Subject: Objection to HGY/2024/0506

Case Reference: HGY/2024/0506

Location: 42 Seymour Road, Hornsey London, N8 0BE

CONSULTATION
RESPONSE: MARK-UP
OF SUBMITTED
DRAWINGS
28/04/24

B	23/03/24	ISSUED TO CLIENT FOR COMMENTS	VP
A	27/10/23	ISSUED TO CLIENT FOR COMMENTS	VP
REV.	DATE	PURPOSE	DRAWN
CLIENT Mr SANJ BUNDHOO			
PROJECT SIDE AND REAR EXTENSION			
TITLE PROPOSED EXTERNAL ELEVATIONS			
REVISION B	DWG No. FP/105	SCALE 1:50@ A3	
	DATE OCT '23	DRAWN VP

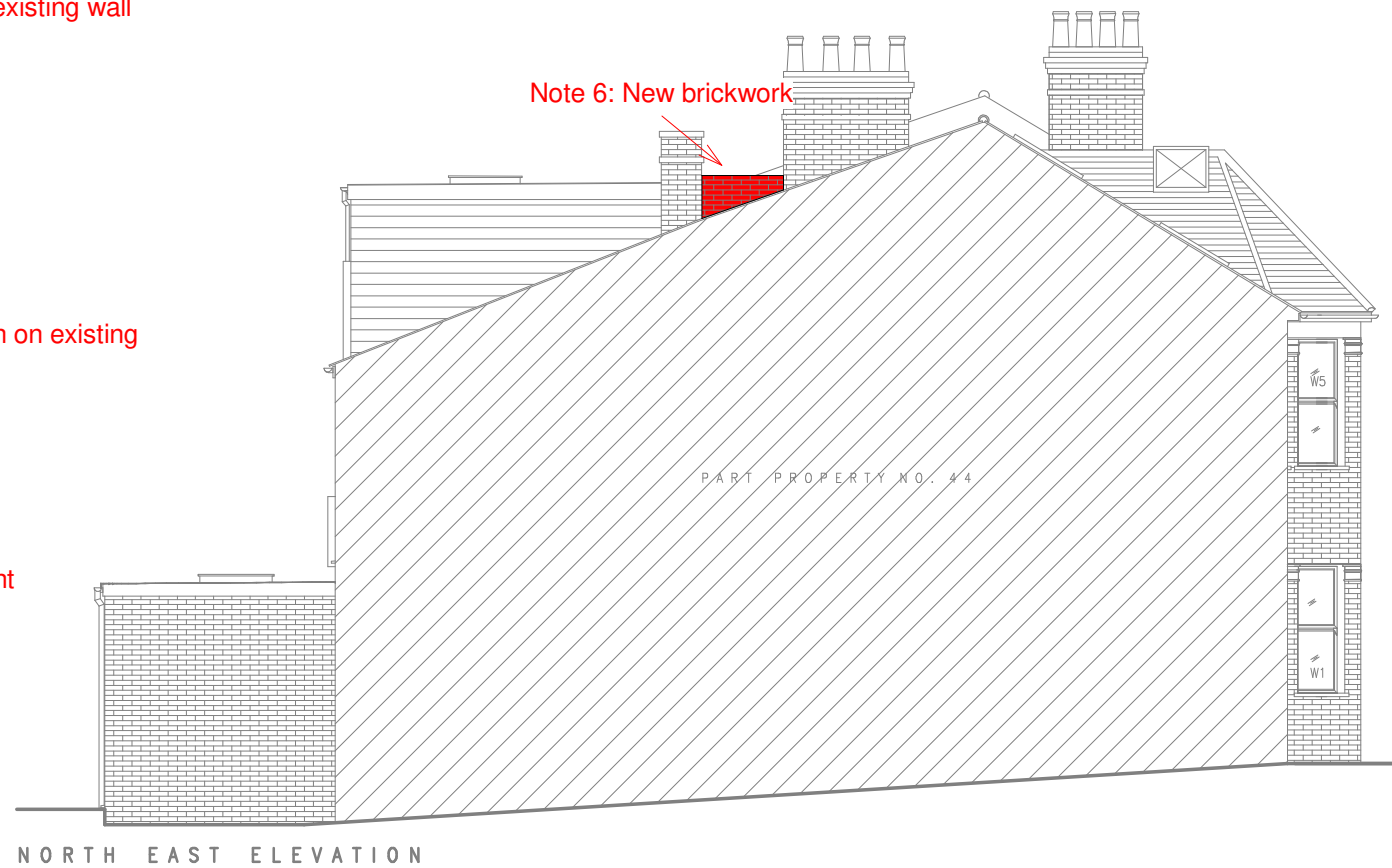
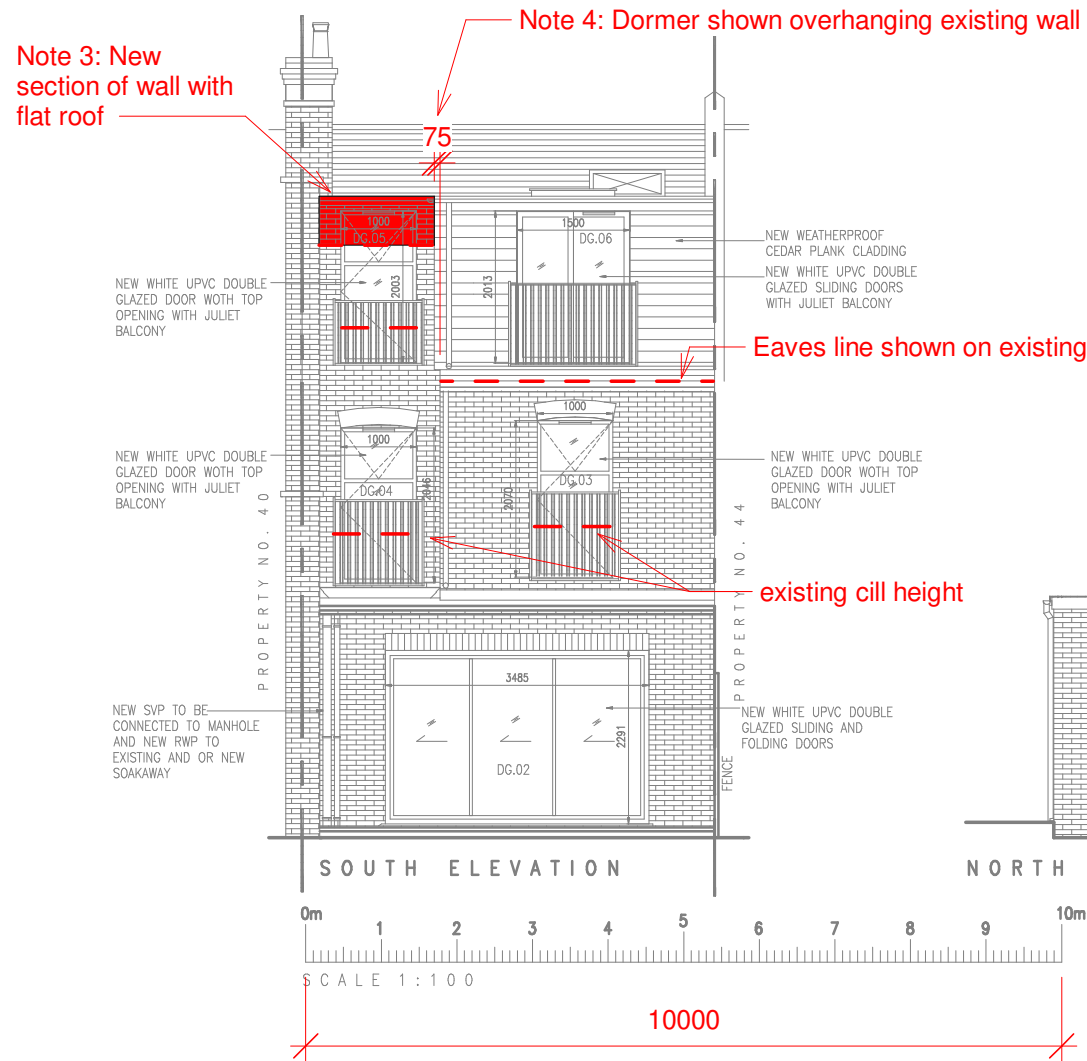
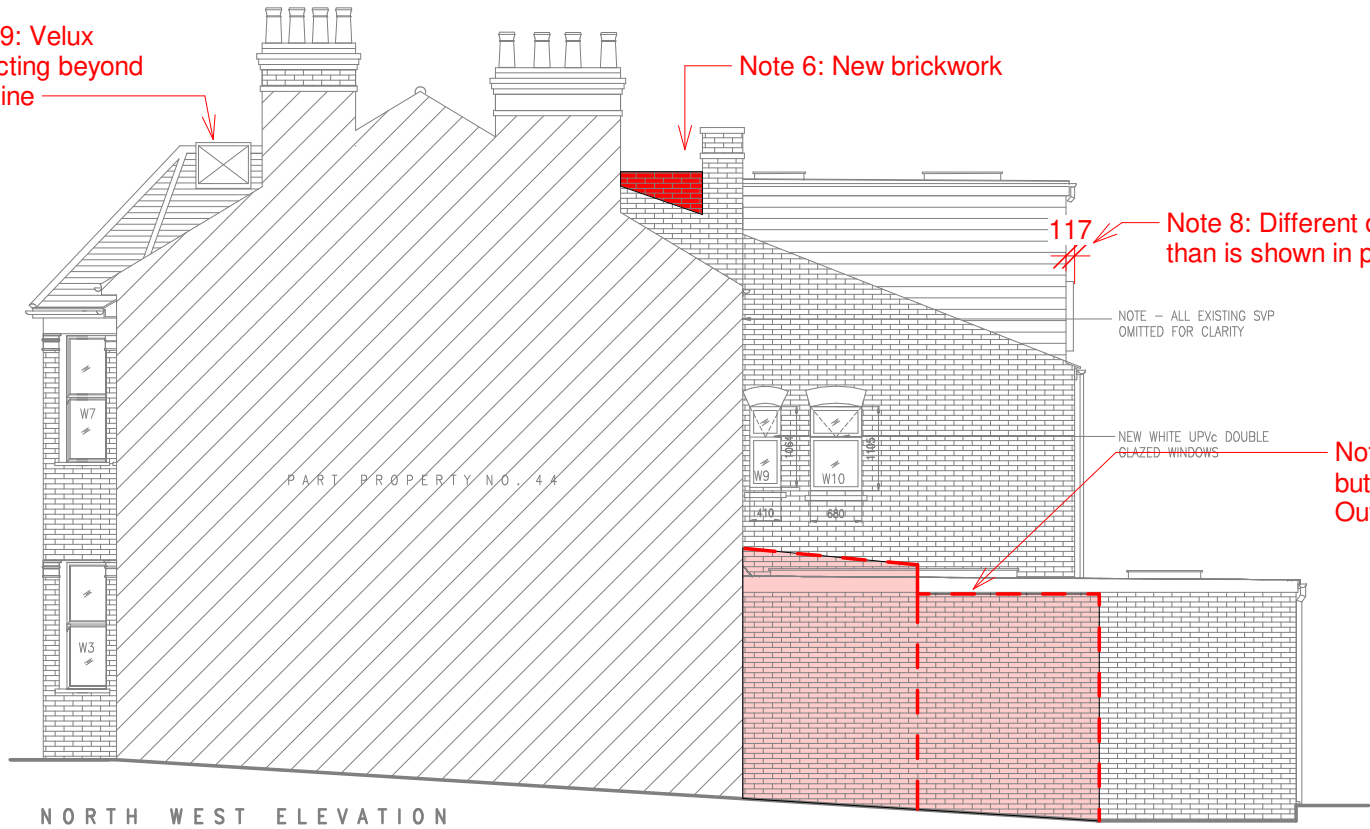
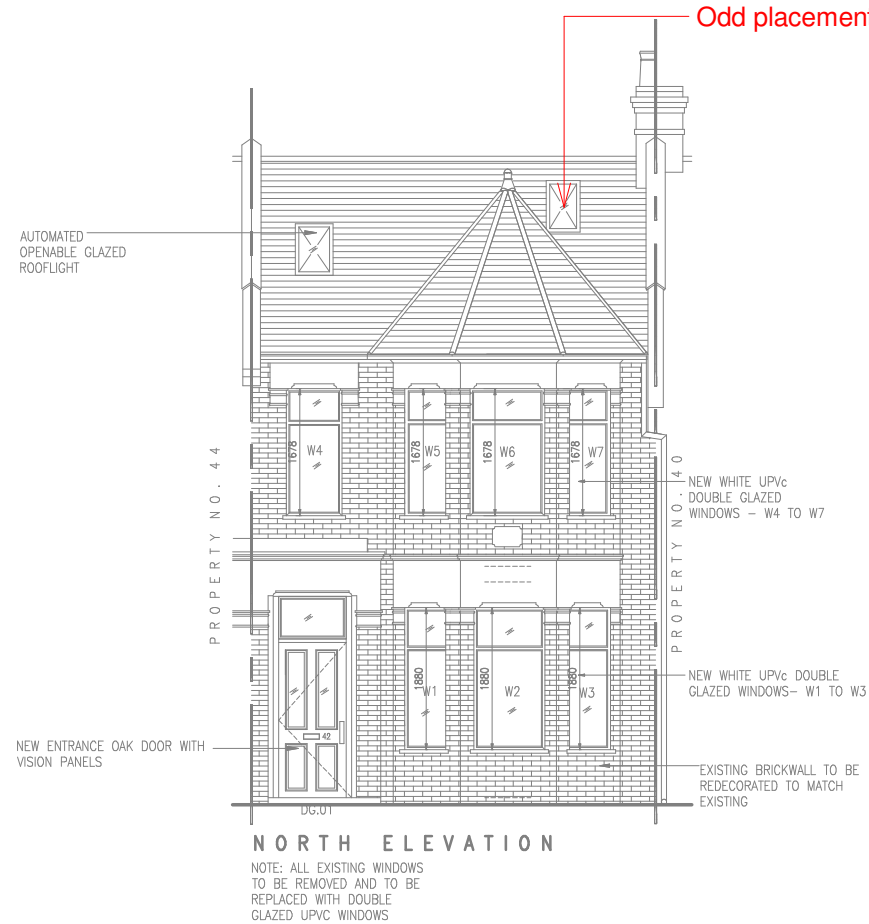
Sections of the proposed dormer are not set back from the existing roof line and will require an increase in height to the existing external south facing wall (see note 3, 4 and 8 of marked up drawings) and therefore the L-shaped dormer is not subordinate to the existing roof.

- The raised eave in the proposed south elevation has not been labelled to indicate the type of materials that will be used to raise the height of this external wall. (See note 6 of marked up drawings)

- There are discrepancies/inconsistencies in the setback dimensions of the outrigger roof extensions (see note 8 of marked up drawings)
- The new Velux window located on the pinnacle, shows the Velux window sitting above the ridge line of the existing roof. It should be situated below the ridgeline and subordinate to the roof (see note 9 of marked up drawings).

Note 6: Gable end incorrectly drawn, this bit doesn't exist currently
